GOVERNMENT OF THE DISTRICT OF COLUMBIA
DEPARTMENT OF TRANSPORTATION

MEMORANDUM

SUBJECT: ZC Case No.07-13D – Randall School PUD Modification, 65 I Street, S.W.

Figure 1 – Public Space Encroachment Truck Maneuvers

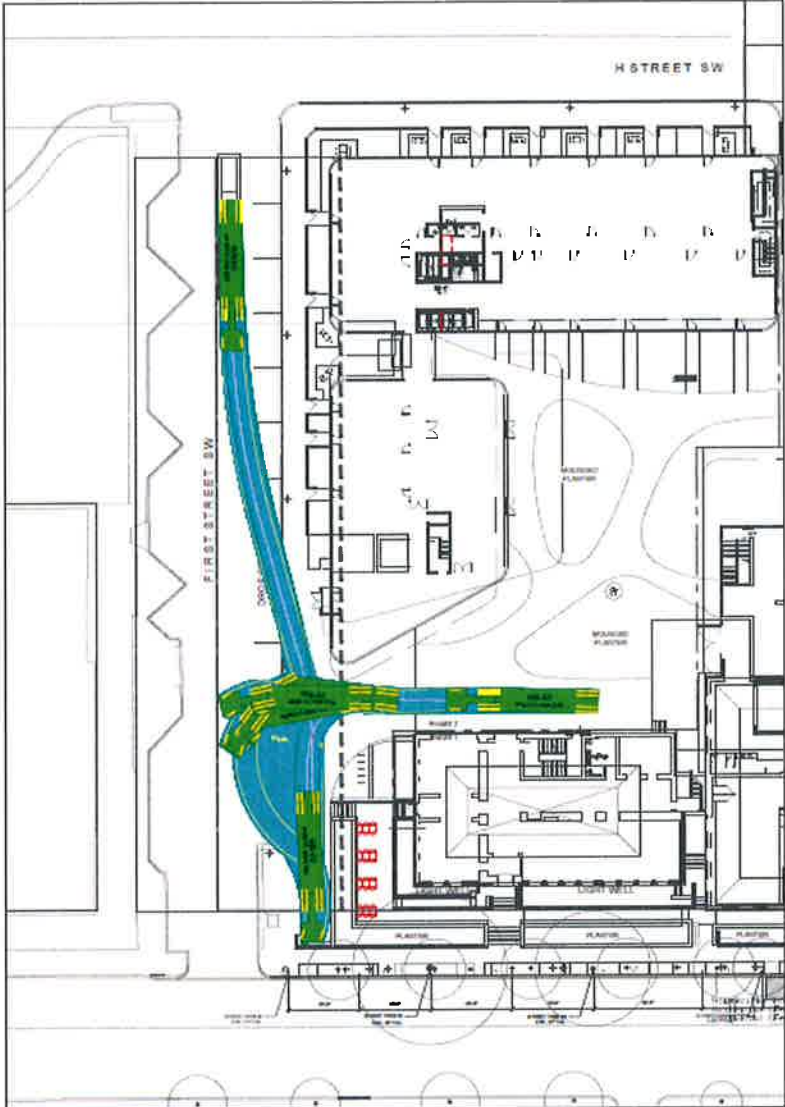
- The vast majority of loading along with their associated truck movements is accommodated on site. However, the secondary loading area, exclusively for museum use, would require back-in truck movements that encroach onto Public Space.

All site access and loading would occur from privately maintained sections of H Street and First Street, SW with the exception of a proposed curb-cut on I (Eye) Street. The site access and loading plan are modified from the previously approved PUD. The Approved PUD includes two separate loading dock entrances and a single curb-cut driveway for the access to the parking garage along H Street. The proposed PUD provides access to the primary loading dock area and the parking garage along H Street, a secondary loading area is proposed along First Street. The loading access from First Street would accommodate 55' tractor trailers for occasional drop-offs and pick-ups of large art installations at the museum. The Applicant is proposing two (2) 40' loading berths, one (1) 30' and no separate service areas. The majority of the project's loading would occur on the lower P1 level of the garage from H Street and would permit trucks entering and exiting the ability to turn around underground resulting in head-in and head-out truck maneuvers. This is an improved condition from the Approved PUD which maintained at-grade loading docks requiring back-in movements along H Street. However, DDOT is concerned with the proposed truck maneuvers along First Street which would require trucks to encroach onto Public Space. The Applicant must continue to work with DDOT to assure that Public Space is not negatively impacted by truck maneuvers on the Subject Property. Figure 1 illustrates how truck loading maneuvers from First Street could potentially impact public space.

- Vehicular idling or queuing in the proposed turnaround does not impact public space.
- Back-in truck maneuvers that encroach onto public space are eliminated.
- The Applicant commit to work with DDOT during the public space permitting process to resolve public space issues including but not limited to the proposed reserved curb-side spaces, valet operations, curb-extensions, and short-term bicycle parking.

Figure 2: Half Street Turn-around Queuing Diagram

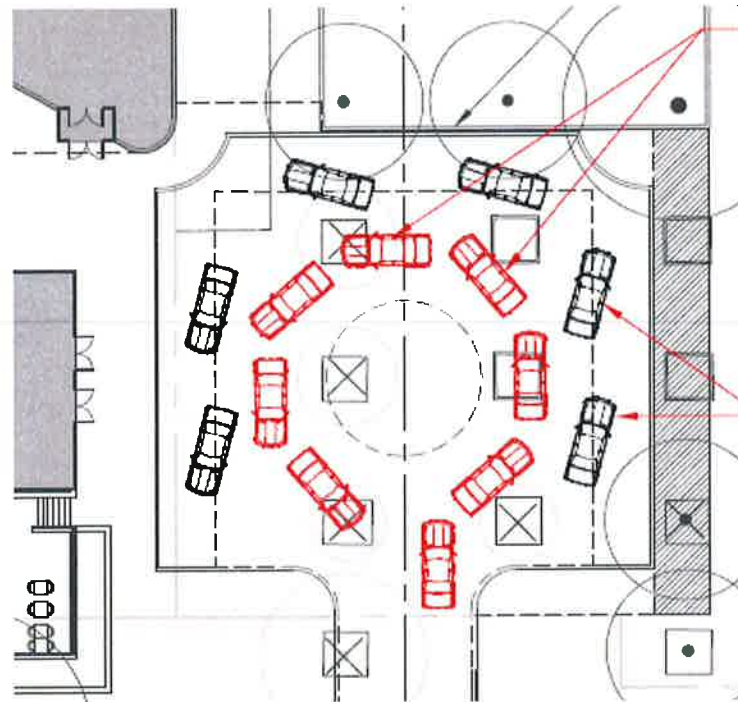
The modified PUD also includes a proposed extension of Half Street and turnaround area at the eastern edge of the property. This turnaround would serve as a drop-off and pick-up area for the development and the adjacent public recreation center. The Applicant proposes that the turnaround area would also serve as the valet staging area for the development's restaurant. However, information pertaining to the location of a valet stand and vehicular circulation plan for the valet operation were not included with the CTR. The Applicant will be required to submit this information during the public space permitting process. DDOT is generally supportive of the Half Street Turnaround concept, but has concerns with potential queuing problems based on the proposed dual operation of the turnaround with both valet staging and drop-off/pick-up functions.

The Applicant provided a queuing analysis report indicating that traffic is not expected to spill over onto I Street based on assumptions of brief dwell times for valet users and passenger drop-offs and pick-ups. However, the findings are based on scenarios where vehicles do not double park or block queuing lanes. The proposed dual purposed turnaround also has the potential to result in driver confusion where motorists are uncertain of which is lane is for valet service and passenger drop-off/pick-up. All vehicular queuing must be maintained within turnaround area and not spill over onto I Street, SW. To assure that no vehicular idling or queuing impacts public space or traffic operations on I (Eye) Street DDOT recommends that an on-site staff member is designated to direct vehicles utilizing the Half Street turn around. Figure 2 illustrates that a maximum of 14 vehicles can utilize the turnaround before queuing impacts Public Space.

Figure 3 – Study Area

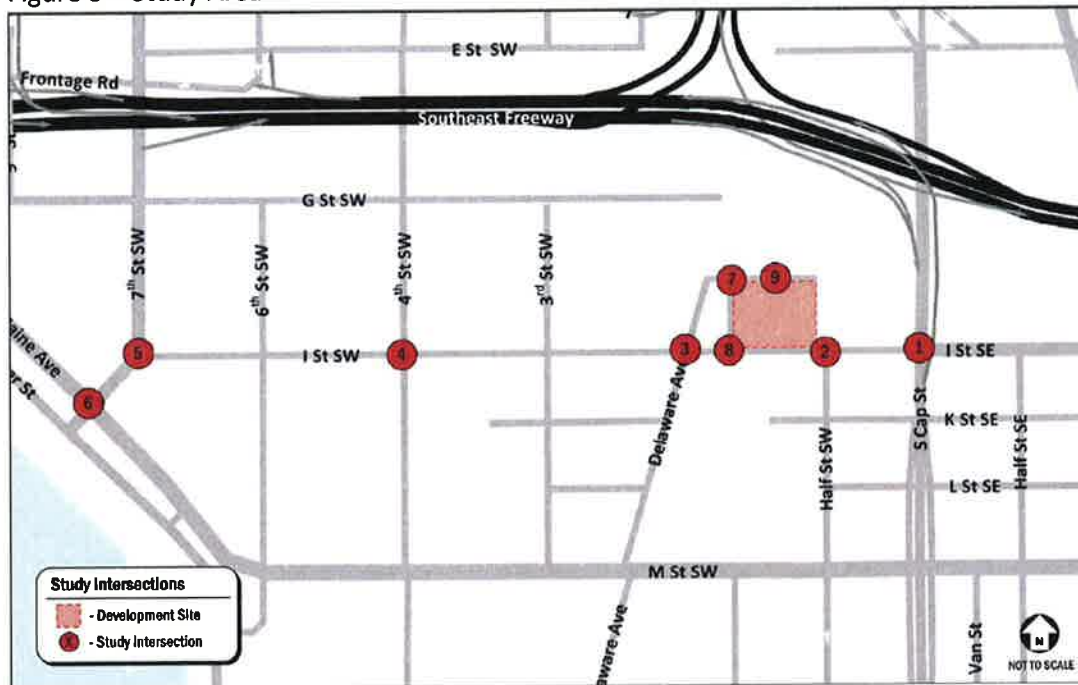
DDOT and the Applicant agreed that 9 intersections and all site driveways would be included in the updated study area as identified in Figure 3. The Applicant used the Highway Capacity Manual methods to evaluate the intersection capacities under the existing conditions (2013), background conditions with and without the proposed PUD (2016). Under all scenarios the LOS remained either consistent or better than reported in the original CTR associated with the Approved PUD. Overall all intersections maintain a LOS D or better under existing conditions, background conditions, and total future conditions. The eastbound approach at I Street and S. Capitol Street maintains LOS F in both existing conditions and total future conditions however this intersection will be redesigned to address traffic and safety issues as part of the South Capitol Street Corridor Project.
